RE: Requested Additional Materials (BZA Application # 16260)

Re: Proposed Addition

It is the purpose of this letter to outline the design intent of the proposed addition to the above address and to address the concerns raised by others regarding this design.

JOB NUMBER	
PROJECT NAME	DIAGRAM "1" EXISTING ROOF ELEVATION
DATE	10.14.97
SCALE	1/4"=1'0"
SKETCH NO.

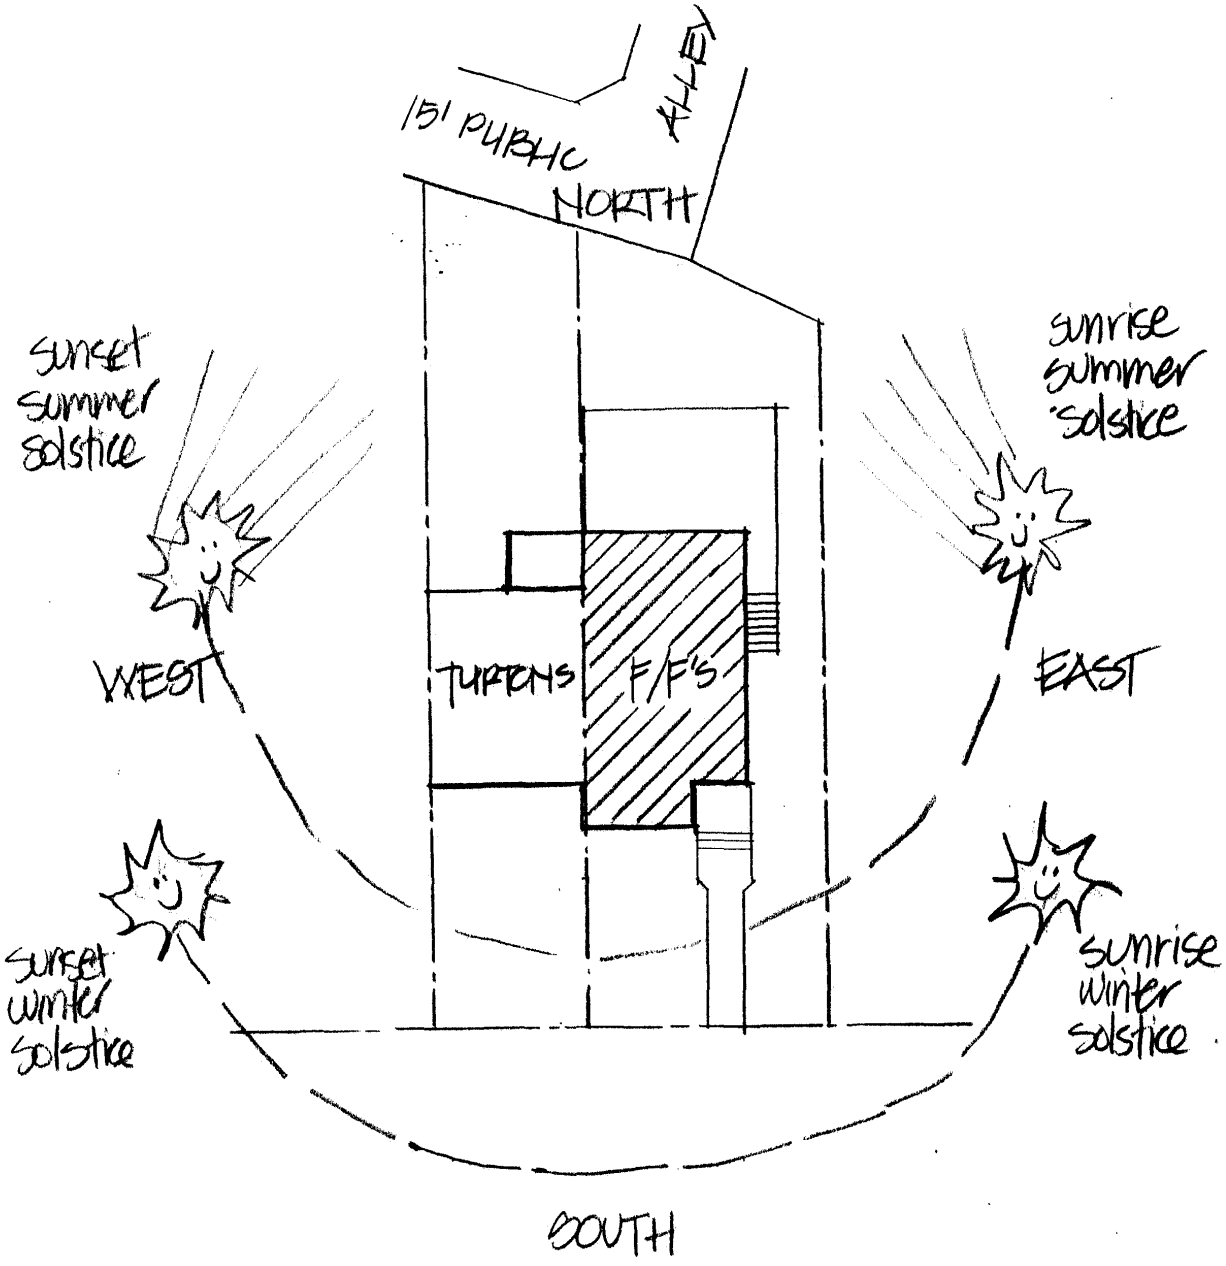
1. Since the roof opening in question-(indicated to be a window but as is seen in Photo No. 2, actually a ventilation louver)- is in fact a louver, it is not meant to be seen out of but rather provide ventilation to the attic. *See Diagram 1.*

This photo corresponds to the diagram of the north elevation. It shows the existing 39" distance between the wall of the Furchgott/Fleischmann dormer (barely visible to the left) and the Turtons fully-louvered dormer. The property line midway runs between the two pipes (where a water-flow diverter will be placed). The distance between to venting louver and the wall is three-times the minimum required distance for unobstructed air-flow.

JOB NUMBER		PROJECT NAME	DIAGRAM "2" NO DIRECT SUNLIGHT OBSTRUCTED BY PROJECT	SCALE	1"=20	SKETCH NO.
				DATE	10/13/97

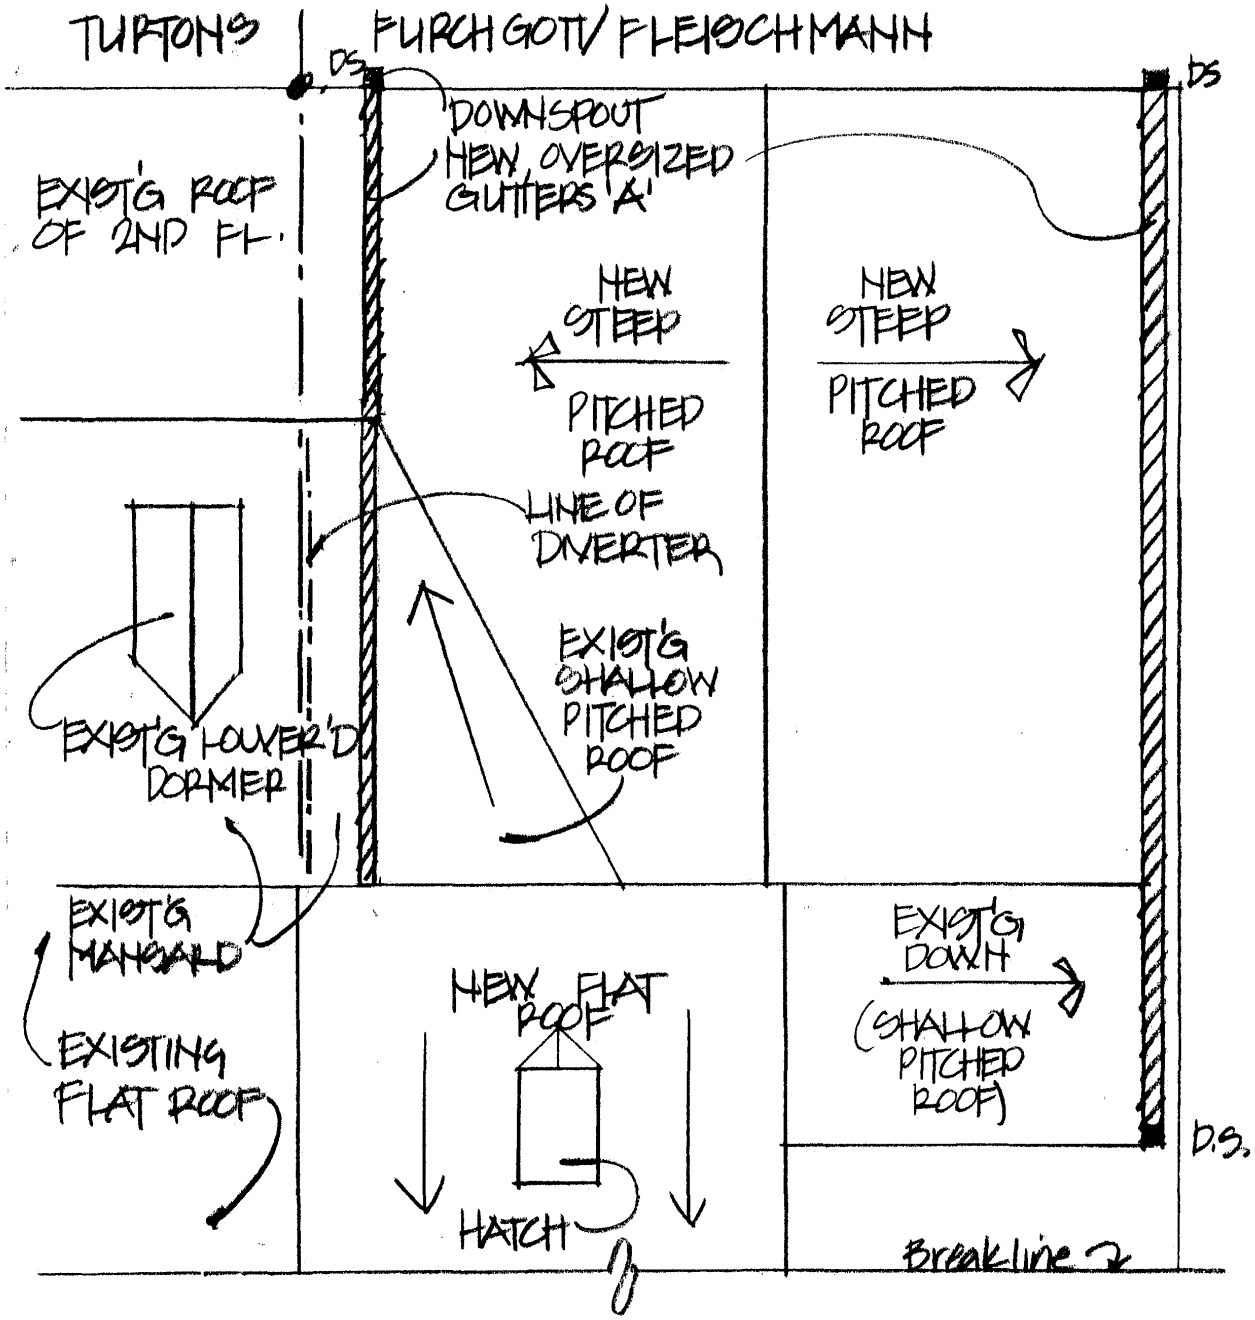
2. The window and louver in question on the adjacent property owners unit faces North and as such receives no direct sunlight other than early morning in late spring . See *Diagram 2* for the angle of the sun in the Washington area in relationship to the structure. The proposed renovation will have no additional effect on the light entering the rear of the middle unit top floor room. Again, since the window nearest the Furchgott/Fleischmann residence is actually a louver, it seems a mote point. Most mechanical engineers request at least a foot clear around the sides of louvers such as this for ventilation and three feet in front. Since the louver is 19" from the property line and the proposed addition is set back 20" from the property line-providing a total of 39" there will be no impact on ventilation from the proposed renovation.

3223 KHINGLE ROAD N.W.
A NORTH FACING WALL @ 38-39° LATITUDE
RECEIVES NO DIRECT SUNLIGHT

JOB NUMBER	PROJECT NAME	SCALE	SKETCH NO.
	DIAGRAM "3" NEW ROOF & DRAINAGE	1/4"=1'-0"	
		DATE 10.13.97

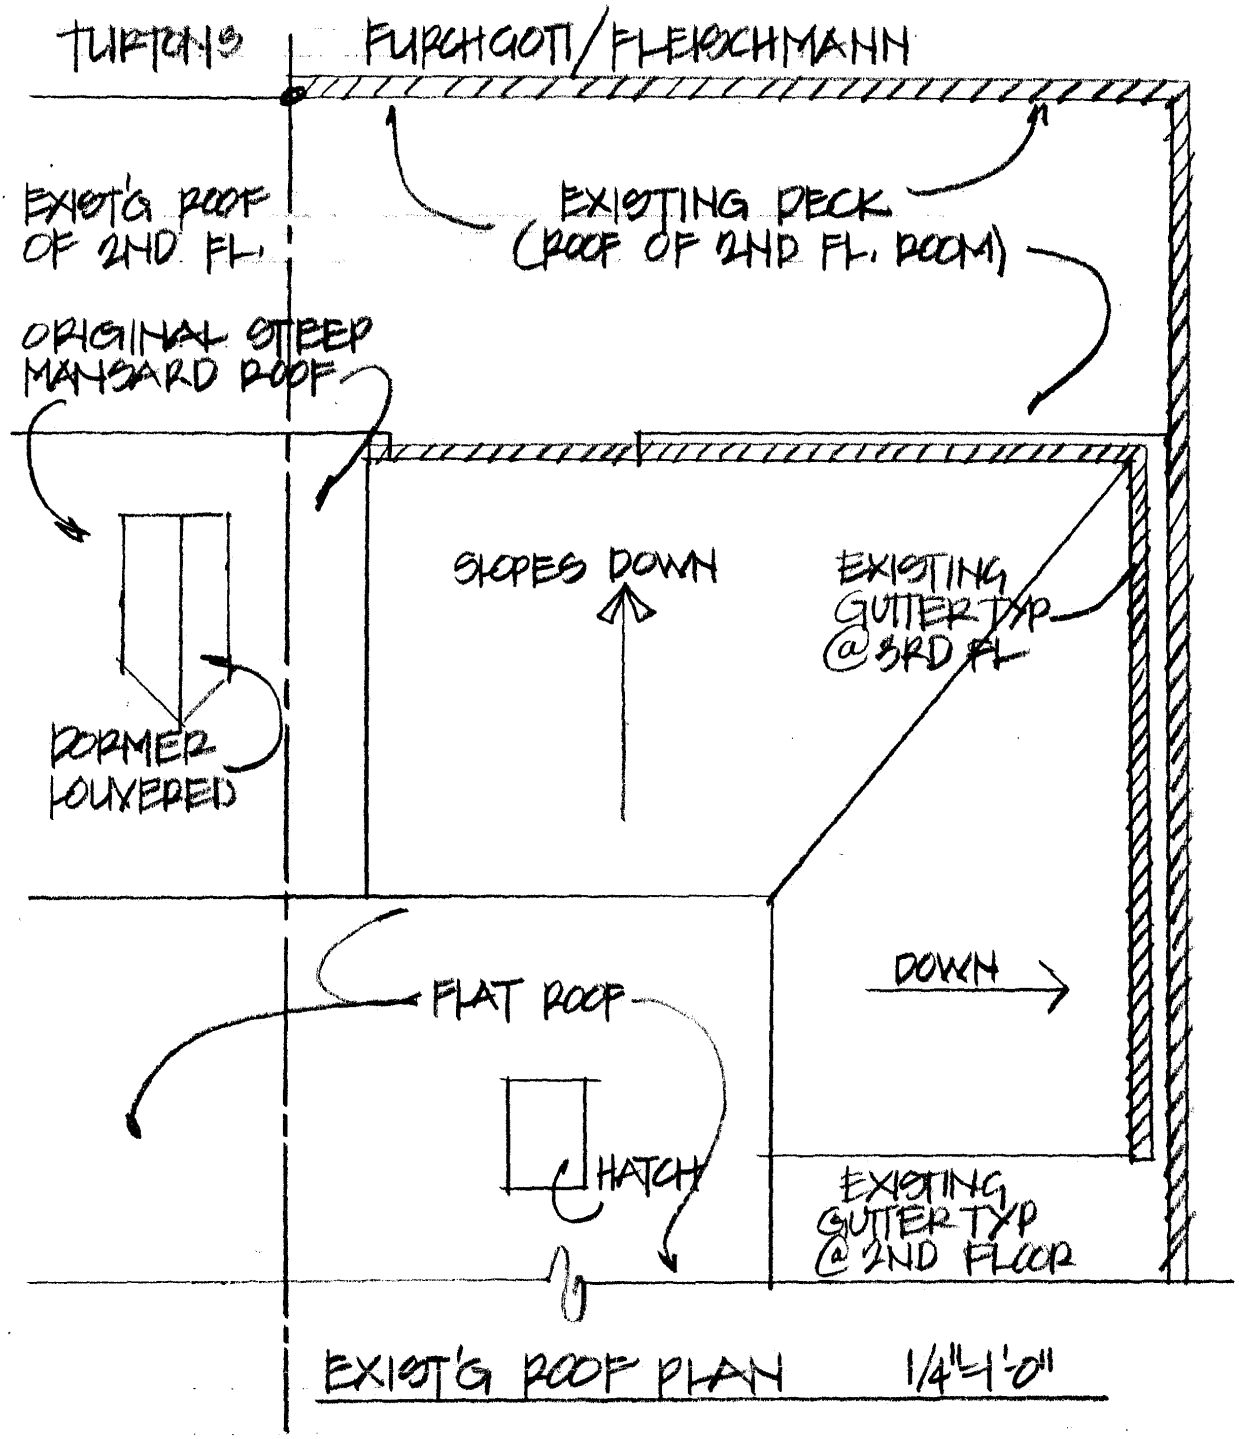
b. The new roof design will cause snow accumulation of the new roof which will run off and slide onto the flat, second-floor rear roof of the middle unit. The combined weight of snow accumulation from these two sources may result in a snow load which would exceed safe load limits for the middle unit's present flat roof.

c. The new roof will increase the probability of roof leaks occurring on the flat, second story roof of the middle unit as the new design may result in the diversion of water from the end unit's roof to the center unit's roof.

3. These homes are built of masonry load bearing construction with wood framed flooring and roof members. Units are framed side to side (floors and roof bear on side walls.) Since each unit acts independently, although two adjacent units share the "party" wall for bearing on one side of the unit, there is unlikely that additional loads on the Furchgott/Fleischmann structure will transfer to the middle unit. This is however a structure of some age and it is impossible to know how weight may have shifted over time. A structural engineer has been involved in this project from the design phase and will be involved in the construction phase. Water drainage from the new roof has been taken into account. All gutters have been sized beyond their required need to accommodate heavy rainfalls, a gutter runs along the side of the roof abutting the adjacent property until it intersects the existing roof and then a diverter is proposed to deal with any other water above that. See *Diagram 3.* It is intended that a heat-tape system be installed in the gutters on the side of the gable roof facing the adjacent property to melt the snow.. Melted snow will then flow more rapidly into the gutters and down to the ground below. It is not possible to calculate potential wind driven snow accumulation. Also note the attached letter from Ms. Fleischmann's roofing contractor regarding the proposed guttering system.

JOB NUMBER	
PROJECT NAME	DIAGRAM 'B' RELATIONSHIP OF TURTON ROOF TO PROJECT
DATE	10.13.97
SCALE	1/4"=1'-0"
SKETCH NO.

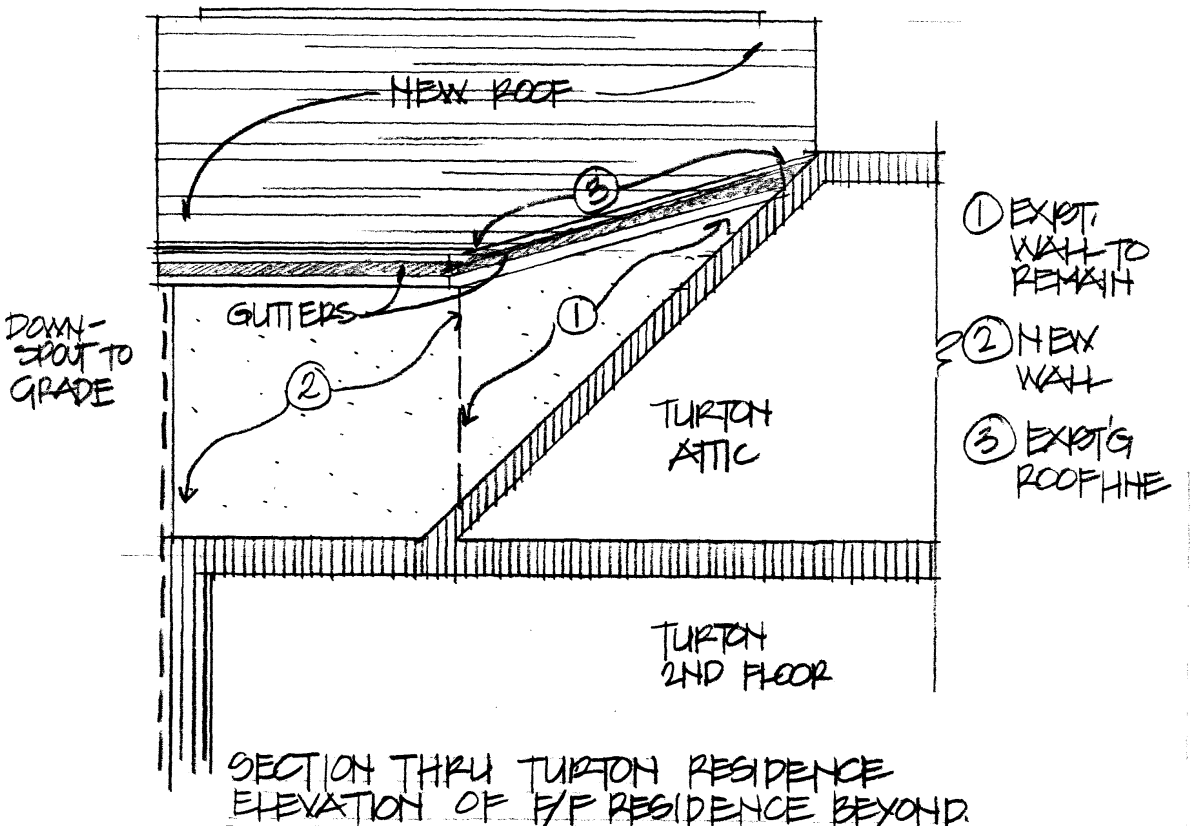
Our proposed renovation design will demolish most of the rear wall and roof of the previous addition at the rooftop of this house. Both this roof and wall have contributed to the water damage of the floor below. We will also remove the roof top deck/roof at the second floor roof where more water damage has occurred. All damaged wood will be replaced where it is found and new walls and roof will be erected. New windows meeting current energy requirements will be installed, and aligned with existing windows below in order to give the rear elevation of the house a more orderly appearance. Existing rustic cedar siding will be replaced with an exterior insulating finish (synthetic stucco) in keeping with the stucco found on many units throughout the neighborhood. The interior of the space created will be used as a master bedroom and an enlarged bathroom for the Furchgott/Fleischmanns. *See diagram 5* for relationship of existing Turton roofline to proposed F/F roofline.
